Subject: CARGO COMPARTMENT LIGHT BULB REPLACEMENT CAUTION	Bulletin No: 09-023/12
	Last Issued: 07/03/2012

2013 CX-5

2683b

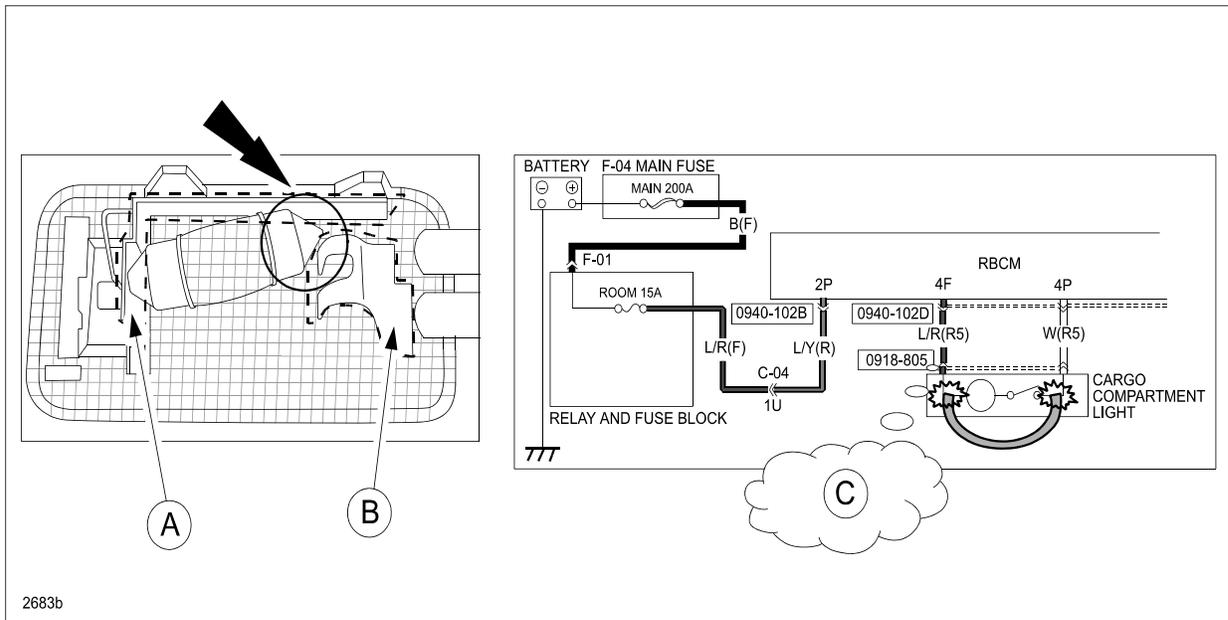
- TO AVOID DAMAGING THE RBCM DURING CARGO COMPARTMENT LIGHT BULB REPLACEMENT, ALWAYS DISCONNECT THE NEGATIVE BATTERY CABLE OR THE CARGO LIGHT CONNECTOR.
- If the bulb is removed (by hand or with a screwdriver) and battery power is still supplied to the cargo compartment light, the metal end of the bulb could cause a short circuit (C) between the negative (A) and positive (B) electrodes (as shown below). If this occurs, the RBCM will be damaged and will require replacement.

1. Verify customer concern.
2. Disconnect either the negative battery cable or the cargo light connector.

3. Replace the light bulb with a new one.
4. Re-connect the negative battery cable or the cargo light connector.
5. Verify repair.
